Re: [HVO North Open Cut Coal Continuation Project](#), Application Number SSD-11826681, and [HVO South Open Cut Coal Continuation Project](#), Application Number SSD-11826621

IEEFA has reviewed the HVO North and HVO South Open Cut Coal Continuation Projects' amended economic assessment ([Appendix M – Economic Assessment](#)) compiled for the proponents by the consulting agency EY. Our findings are summarised below and detailed in this submission.

Figure 1: Proponent's assumed coal price forecasts in real 2025 prices (\$/t)

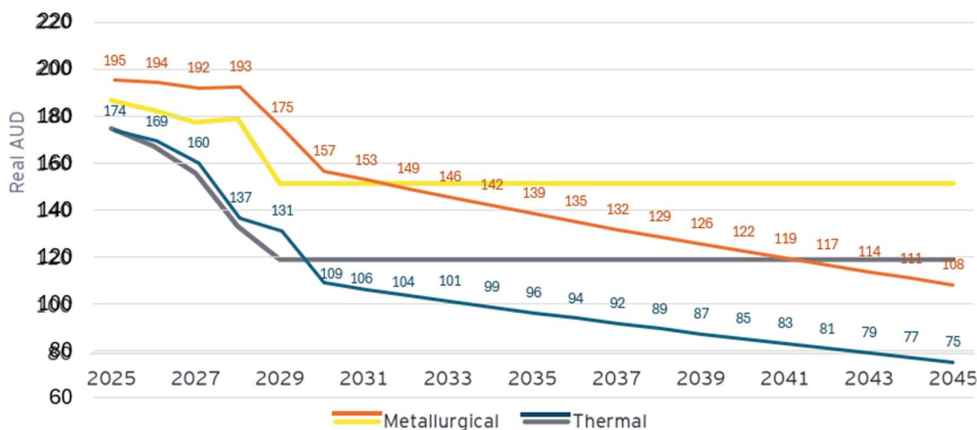
The proponent states that the projects' economic assessment and subsequent calculation of assumed NPV of realised coal prices over the life of the projects is based on KPMG Coal Price and FX Market Forecasts, March/April 2025, adjusted to 2025 real prices using Office of the Chief Economist June 2025 inflation rates and then reported in NPV terms by applying a 7% discount rate. However, the proponent's projected price assumptions in 2025 real terms through to 2045 (Figure 7 of the Economic Assessment) do not reflect their stated assumptions.

Figure 1 below shows what the coal price should look like based on the proponent's assumptions and source data (blue & orange) compared with the price assumptions in the CBA, Figure 7 (grey & yellow).

The CBA calculates the total project revenue to be \$39.7 billion over 19 years in real undiscounted 2025 Australian dollars, or \$20.8 billion dollars in NPV terms. However, recreating this NPV value by using the assumptions stated in the Economic Assessment, the total combined project revenue from coal sales would be \$33 billion over 19 years in real undiscounted 2025 Australian dollars, or \$18.9 billion in NPV terms. Correcting the error in the economic assessment and applying the proponent's assumptions accurately **means the combined NPV of the project would be almost \$2 billion lower.**

Figure 5: NSW reported GHG emissions and targets vs HVO estimates (Mt CO₂e)

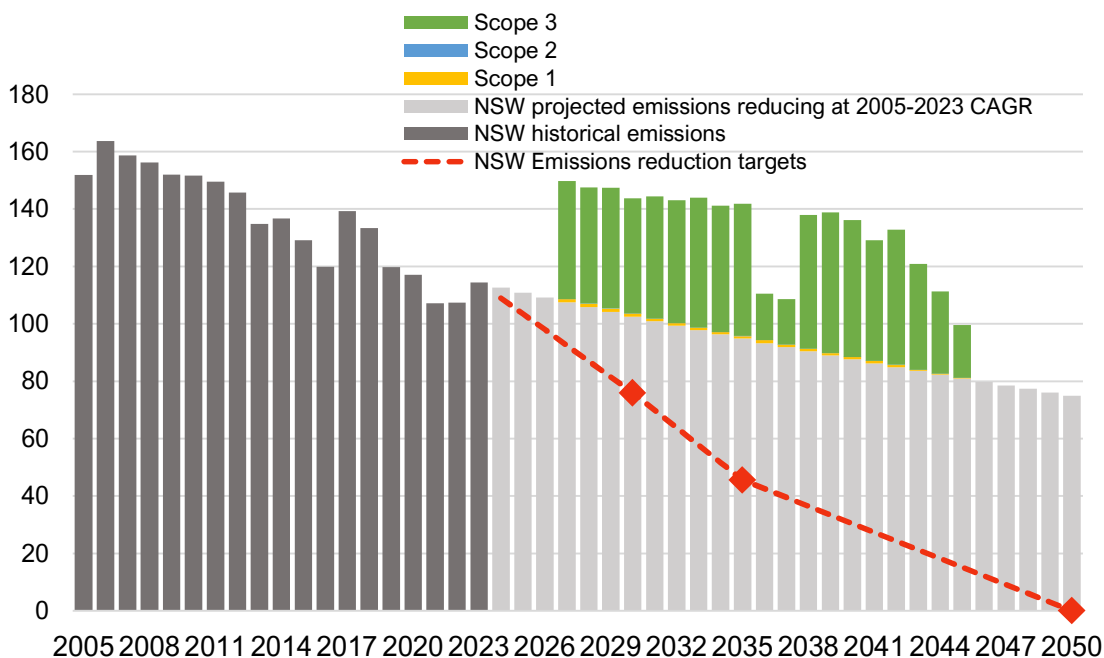
By far, Scope 3 emissions are the biggest contributor to GHG emissions from open-cut coalmines such as the proposed projects. These are largely the emissions from consumers burning the predominantly thermal coal from the projects in Australia or overseas. The proponent estimates the projects would produce nearly 800Mt of Scope 3 emissions. This represents about 58% of NSW's targeted emissions, assuming emissions reduce from 2005 levels in line with legislated targets (Figure 5).

Figure 6: HVO projects’ estimated Scope 1 emissions, potential methane underreporting

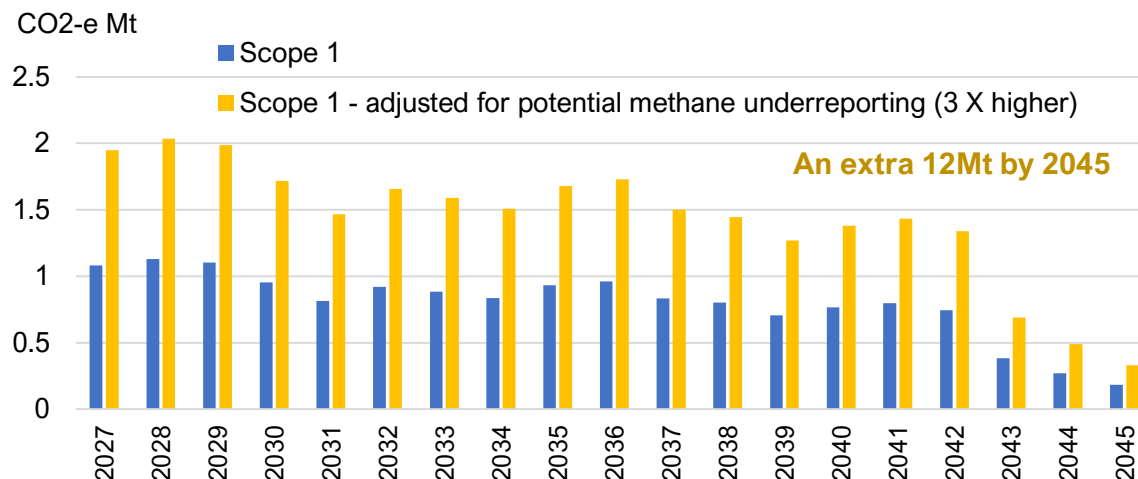
The NSW government’s [Technical Notes](#) on preparing economic assessments state, “GHG estimates should be reported by gas and in carbon dioxide equivalent units.” However, the economic assessment only provides Scope 1 estimates in CO₂e terms, and does not provide a breakdown of estimated GHG emissions by year or gas type. This is problematic because it also does not clarify the conversion rate applied to the methane emissions estimates to convert these emissions into CO₂e units. Additionally, methane emissions from open-cut coalmines in Australia are not measured directly but are estimated using production-based emissions factors. If methane emissions are three times higher than the proponent estimates, Scope 1 emissions would be at least 12Mt greater over the life of the projects.

Figure 7: HVO projects' estimated Scope 1 emissions intensity

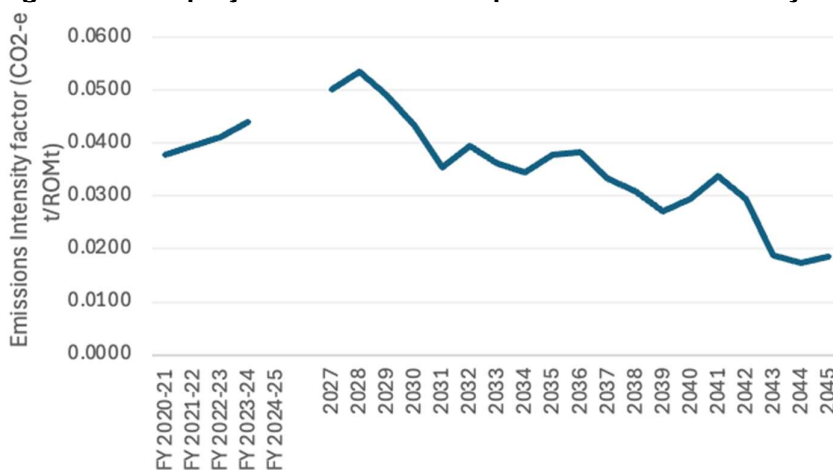
The project's Scope 1 emissions intensity rate is determined based on the proponent's GHG assessment. The emissions intensity rate is compared with historical performance (Figure 7).

The emissions intensity rate forecast appears to rise initially then fall to below historical rates for the duration of the project. The reasons for this are not clear from the documentation provided or whether it is a result of erroneous emissions assumptions. The proponent states that the average Scope 1 emissions intensity over the life of the Amended Project would be 0.0352t of CO₂e per tonne of ROM coal.

Figure 8: Estimated methane emissions underreporting by Australian coal, oil and gas

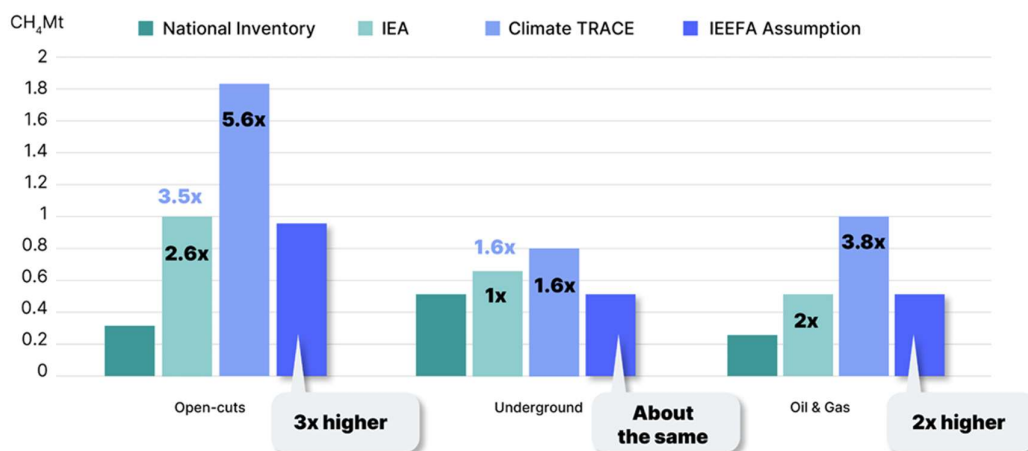
There is a growing body of evidence that reported methane estimates from open-cut coalmines in Australia could be significantly underestimated. The Australian government has [calculated](#) the uncertainty in methane emissions reporting by open-cut mines is at least 30%. Additionally, [analysis](#) by the Superpower Institute suggests methane emissions from the fossil fuel sector could be twice as high as reported, and IEA [data](#) suggests open-cut coalmine emissions could be three times higher on average than reported (Figure 8).

The uncertainty of estimated methane emissions from the project should be accounted for in the sensitivity analysis of the CBA and ultimately reflected in the uncertainty on NPV of the total carbon cost of the project. **The NPV of carbon costs from the project can vary based on the uncertainty surrounding the total GHG emissions from the project and the uncertainty of the cost of ACCUs or Safeguard Mechanism Credits (SMCs)** necessary to offset these emissions under the Safeguard Mechanism.

Figure 9: Method 2 actual reported methane emissions intensity vs Method 1 standards

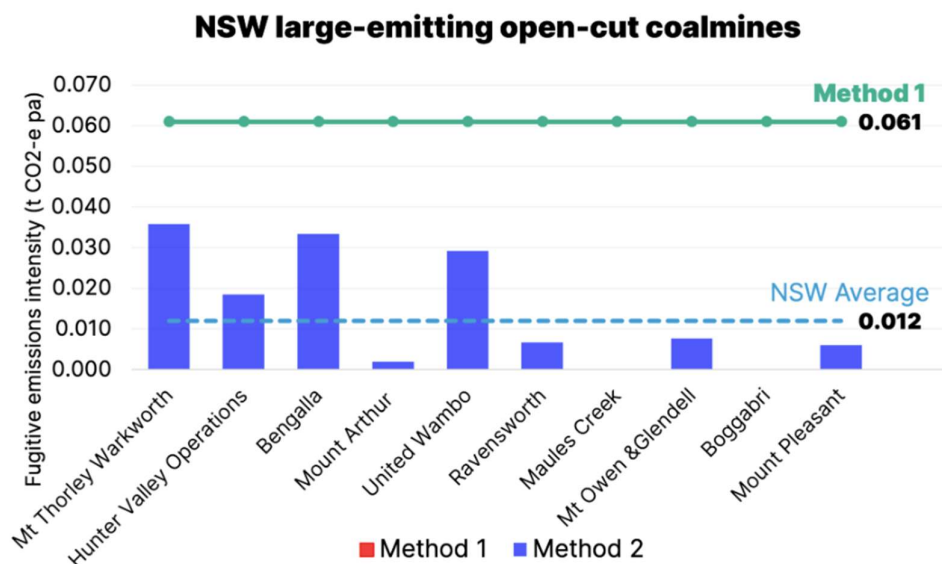
An Australian Climate Change Authority [review](#) of the Methods in the NGER Scheme recommended, “as a matter of urgency, review Method 2 with respect to sampling requirements and standards”. As far back as 2019, [research](#) by the University of Wollongong found the Method 2 approach to determining “low-gas zones” was flawed. This is due to the standards containing an artificially high gas detection threshold and an associated low amount of gas assumed for the low-gas zone effectively underreporting gas considerably. This is most pronounced when high levels of methane are found in the gas (due to gas density differences). The study recommended lowering the threshold gas factor used in Method 2 by an order of magnitude.

HVO uses NGER Method 2 to estimate emissions, the same method as all other open-cut mines in NSW. It reports very low gas emissions by classifying areas such as HVO North's Domain 2 as a "low gas zone". But these readings may be unreliable as gas sampling in that area was taken near a geological dyke, which can distort readings. IEEFA raised some of the issues associated with Method 2, including for HVO, in recent [analysis](#).

Figure 10: HVO's proposed carbon costs vs NSW govt shadow prices

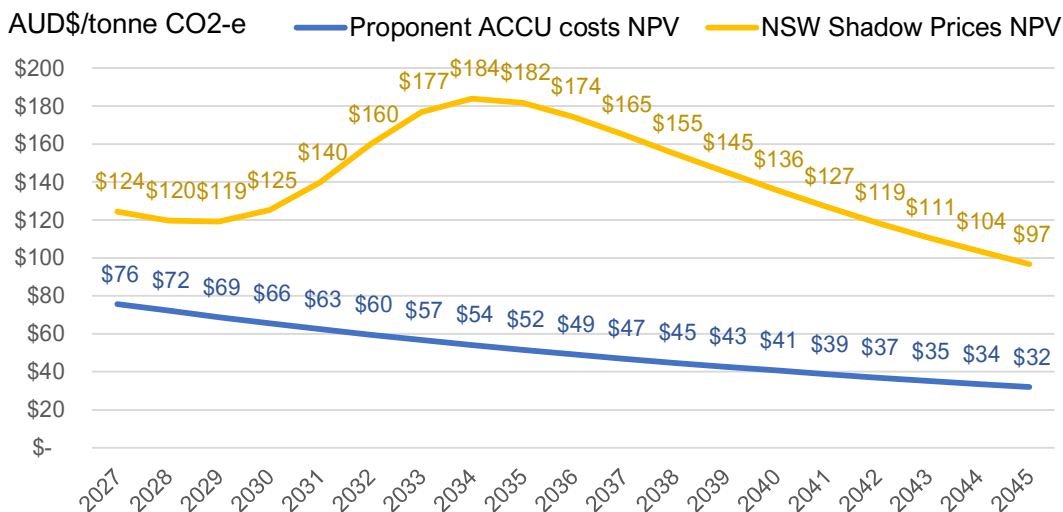
The NSW Government Investment Framework requirements on carbon emissions set out how government agencies must value carbon emission impacts in a CBA. The framework sets out shadow carbon prices to be applied to all carbon emissions. These are \$130/t (rising to \$350/t in 2024 dollar terms by 2040). Using NSW Treasury carbon shadow prices, the proponent's estimated Scope 1 and 2 emissions would equate to a cost of \$2.2 billion over the life of the projects in NPV terms, \$1.5 billion greater than stated by the proponent.

The proponent notes that the costing of carbon credits used in the CBA is “*inherently conservative and was adopted to examine the Project’s cost and benefits through pessimistic assumptions*”. However, this cost falls below the NSW shadow carbon price when both are adjusted into NPV terms using a 7% discount rate.
